FAQ Number 16-0011 FAQ Revision 1

FAQ Title Cable Tray Ignition

Plant: <u>Harris</u>	Date: <u>June 2, 2016</u>
Contact: _____	Phone: <u>(919) 546-4570</u>
<u>Harold Stiles</u>	Email: Harold.Stiles@Duke-Energy.com
<u>Robert Cavedo</u>	Robert.Cavedo@ExelonCorp.com
<u>Francisco Joglar</u>	FJoglar@jensenhughes.com
<u>Kyle Christiansen</u>	ChrisIK@Westinghouse.com
<u>Young Jo</u>	ygio@southernco.com

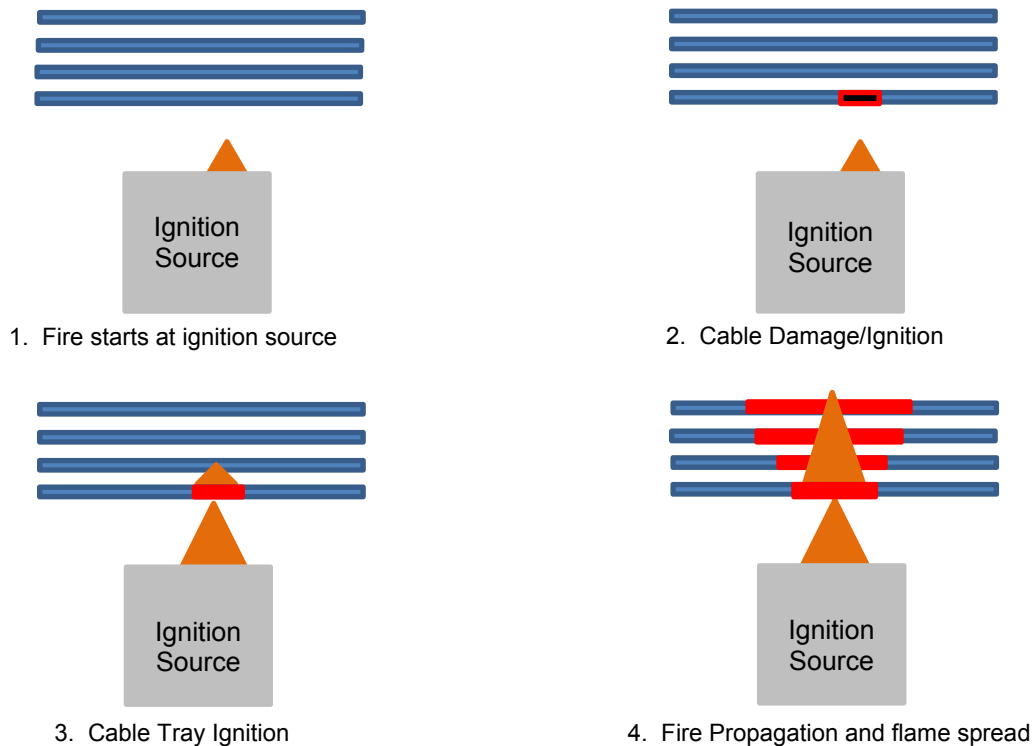
The following sequence provides a conceptual representation of the proposed scenario development for FPRA modeling purposes:

1. Ignition: Fire starts at ignition source generating a zone of influence affecting nearby cables in cable trays or conduits.
2. Cables in cable trays are damaged when exposed to thermal conditions exceeding the cable damage and ignition criteria listed in Table 1. Localized ignition of cables can occur due to shorts; however, the exposures are insufficient to sustain a significant heat release rate (e.g. is a measurable fraction of the ignition source heat release rate). Assume cables are damaged by localized ignition regardless of their location within a cable tray/conduit arrangement if the thermal conditions at the location of the cable tray exceed the cable damage and ignition criteria listed in Table 1.

3. If the analysis is applying the bulk cable/tray ignition criteria in Table 1 (Method 2), or if the analysis is conservatively assuming bulk cable/tray ignition using the bounding thresholds listed in Table 1 (Method 1), and the temperature or heat flux criteria for the applied method is exceeded, then, the resulting pyrolysis rates are sufficient that the entire length and width of the cable tray ignited begins to make a measurable contribution to the heat release rate of the ignition source. The length and width of the initial cable tray ignited used to calculate the heat release rate contribution should be determined following the guidance in Appendix R of NUREG/CR-6850 and/or NUREG/CR-7010 volumes 1 and 2.

4. Subsequent fire propagation and flame spread through a cable tray stack arrangement consistent with the guidance in NUREG/CR-7010, Vol 1.

The above sequence is recommended for growing fires only. The sequence is not applicable for high energy arcing fault fire scenarios. Figure 1 provides a pictorial representation of the recommended sequence.
